E. Conway  
File No: SPA17-031

<b>TO:</b>	<b>CHAIR AND MEMBERS – PLANNING &amp; ENVIRONMENT COMMITTEE</b>
<b>FROM:</b>	<b>GEORGE KOTSIFAS, P.ENG MANAGING DIRECTOR, DEVELOPMENT &amp; COMPLIANCE SERVICES &amp; CHIEF BUILDING OFFICIAL</b>
<b>SUBJECT:</b>	<b>APPLICATION BY: 2376563 ONTARIO INC. c/o ZELINKA PRIAMO LTD. 447 OLD WONDERLAND ROAD PUBLIC SITE PLAN MEETING NOVEMBER 20, 2017</b>

That on the recommendation of the Manager, Development Planning, the following actions **BE TAKEN** with respect to the site plan control approval application relating to the property located at 447 Old Wonderland Road (proposed address of 555 Teeple Terrace):

**PROPOSED LANDSCAPE PLAN**

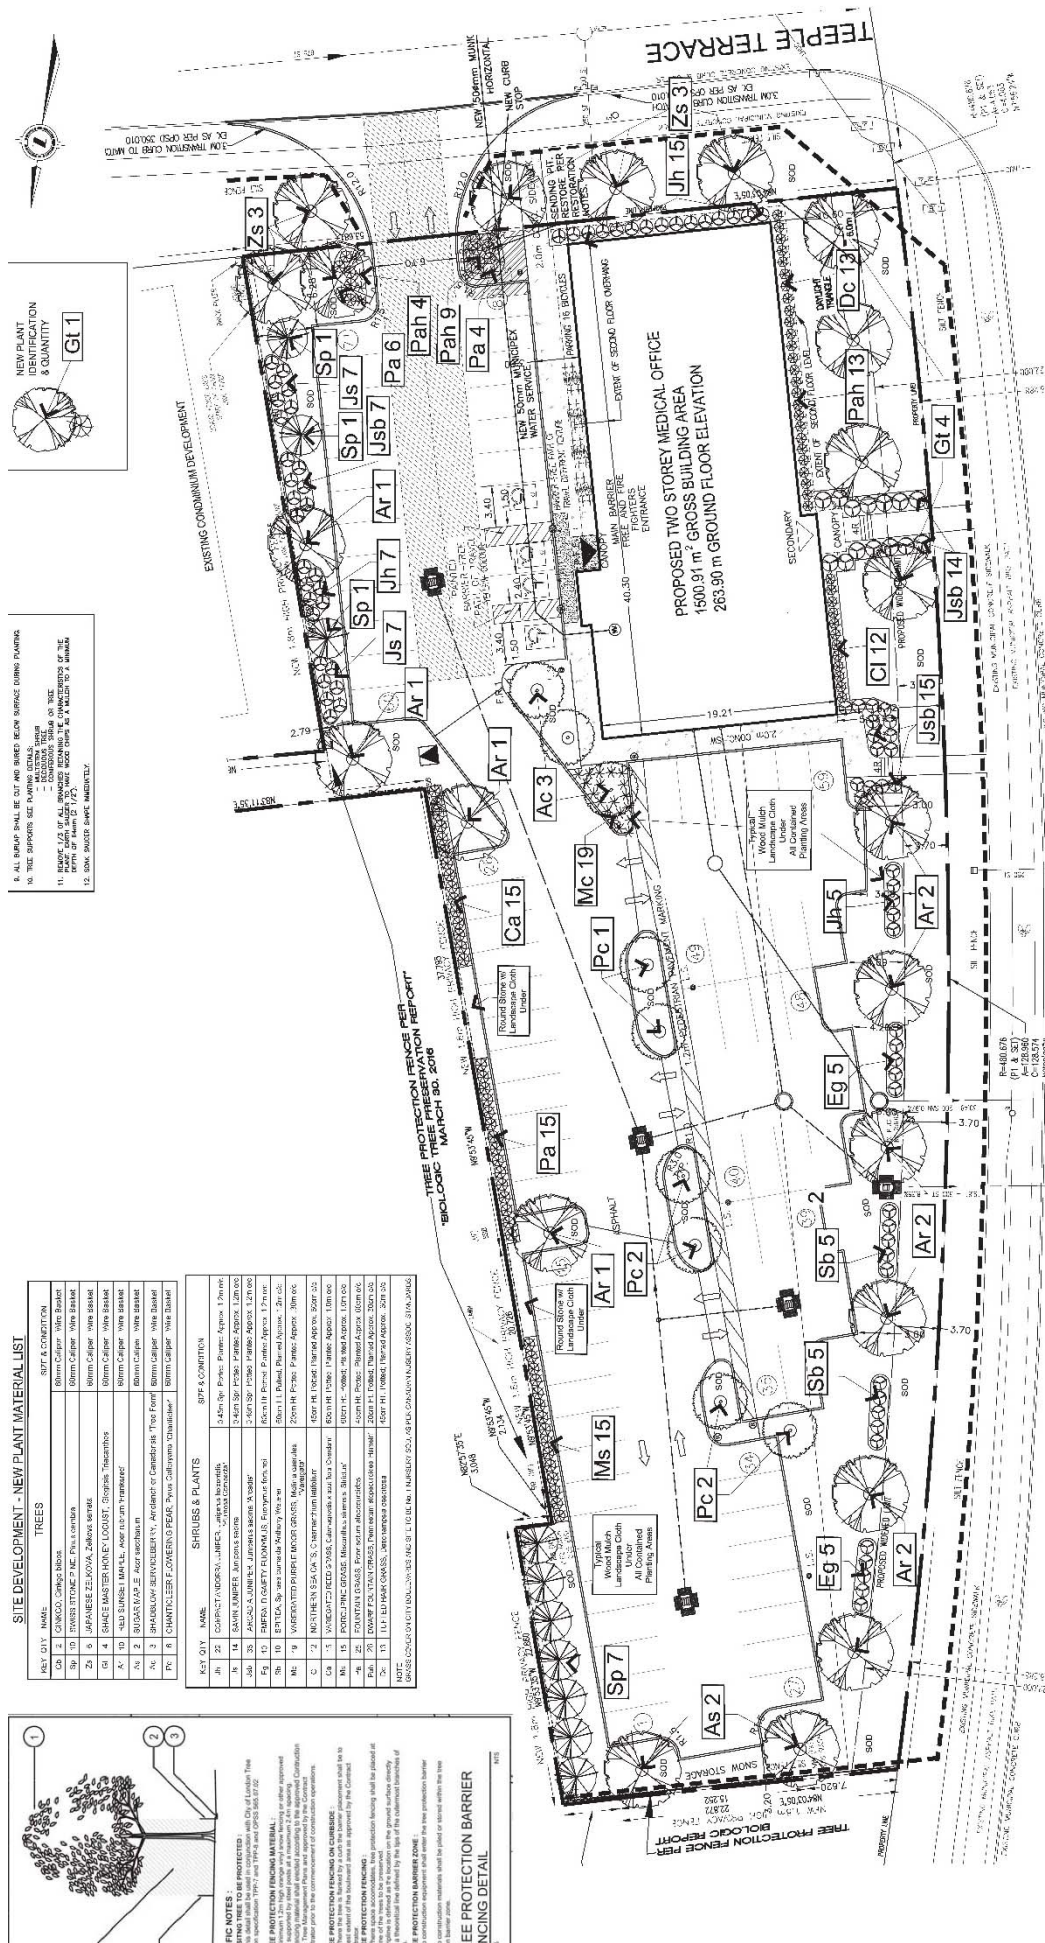
- Relocate plant materials proposed along west side of parking area out of the proposed swale and increase the number of shrubs and low plant materials along the Wonderland Road frontage to adequately buffer the elevated parking area.

- Revise the parking lot island to have understory plantings rather than sod.
- Reinstate the spandrel panels/glazing that was previously proposed (north of the entrance) on the two storey brick portion. The spandrel panels that were proposed between the windows on the first and second story and below the first storey windows helped to break up

- 7) Relocate plant materials proposed along west side of parking area out of the proposed swale and increase the number of shrubs and low plant materials along the Wonderland Road frontage to adequately buffer the elevated parking area.

- 8) Revise the parking lot island to have understory plantings rather than sod.
- 9) Remove tree protection fencing detail from the site plan.
- 10) See OBC checklist. Add OBC matrix to the site plan.

**PROPOSED BUILDING ELEVATION – NORTH AND WEST**

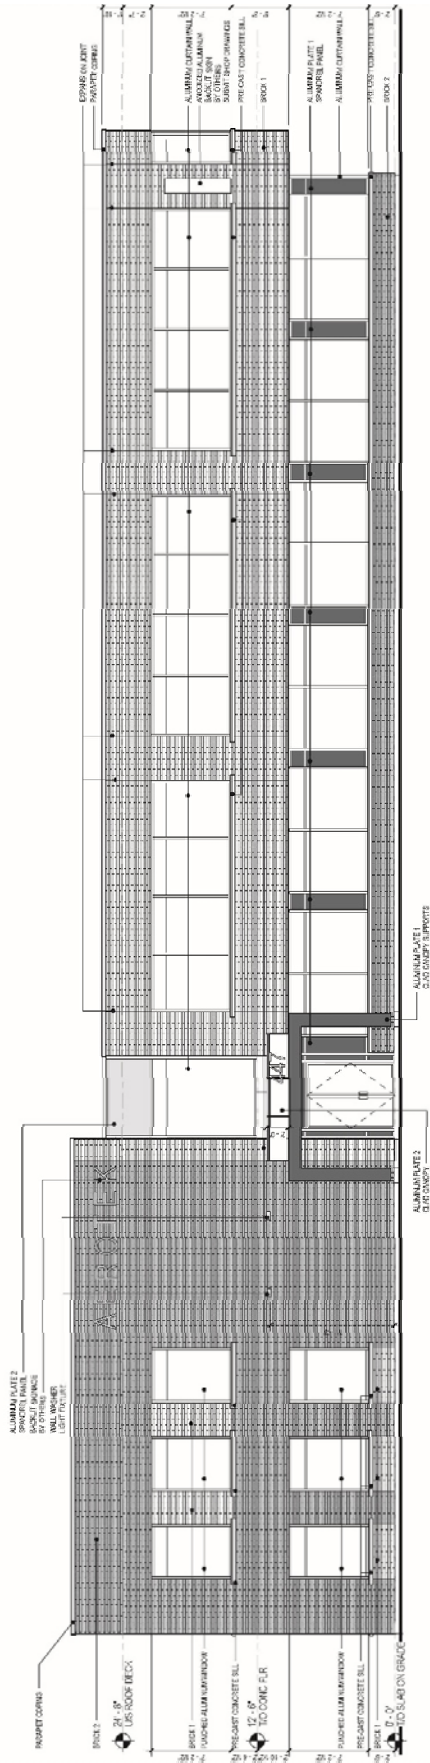
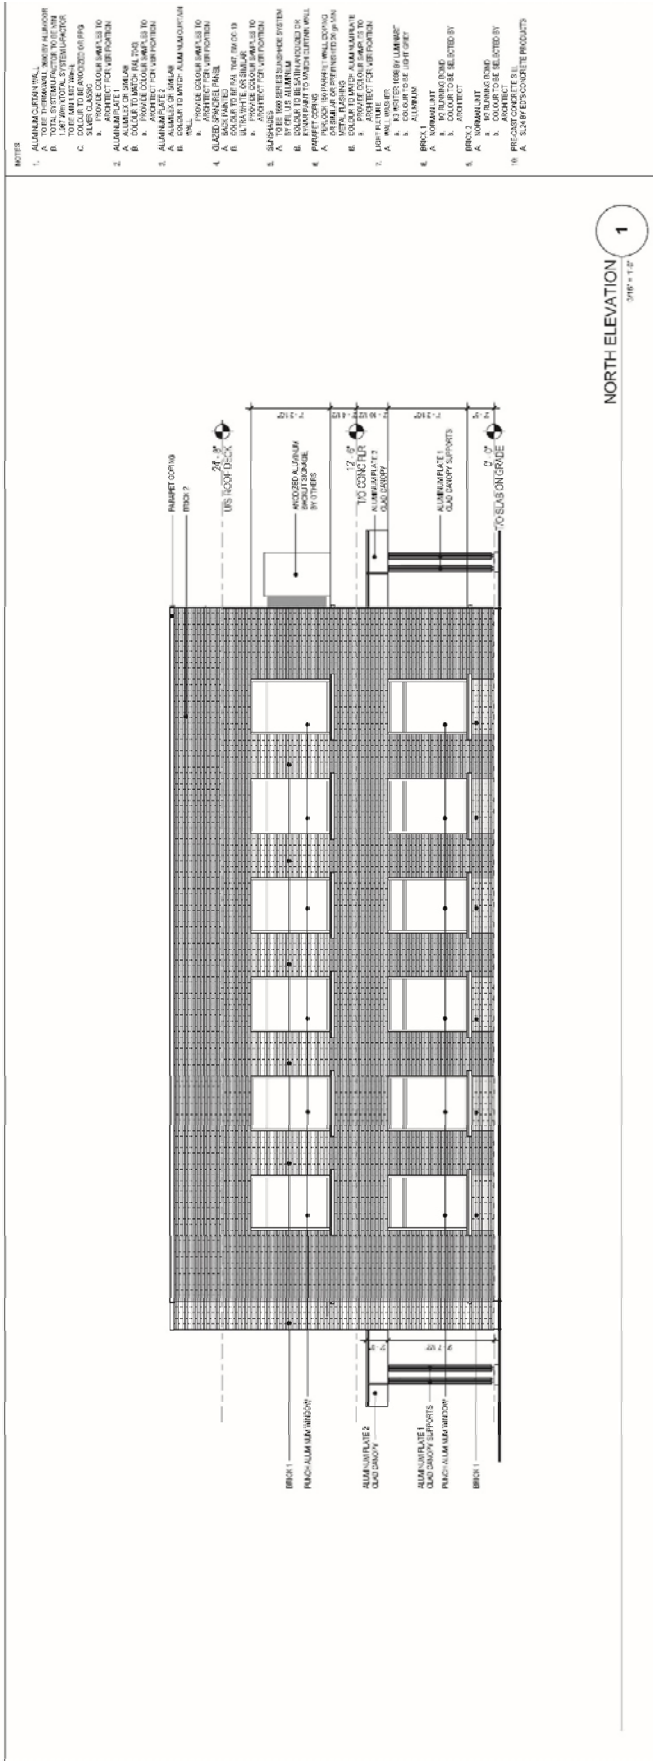
the massing of the two story brick portion of the building (see attached). Alternatively, explore opportunities to use different materials or brick colours to break up the massing.

- Remove the proposed exterior signage from the east side of the building.

- 1) See green-line elevation drawing (east/north) only.
- 2) Reinstate the spandrel panels/glazing that was previously proposed (north of the entrance) on the two storey brick portion. The spandrel panels that were proposed between the windows on the first and second story and below the first storey windows helped to break up the massing of the two story brick portion of the building (see attached). Alternatively, explore opportunities to use different materials or brick colours to break up the massing.
- 3) Remove the proposed exterior signage from the east side of the building.
- 4) Specify privacy film for the second story windows on the north and east sides of the

- building.
- 5) Add metric dimensions to the elevations. Height is measured to the highest parapet. Dimension the building height to the highest parapet on all elevations.
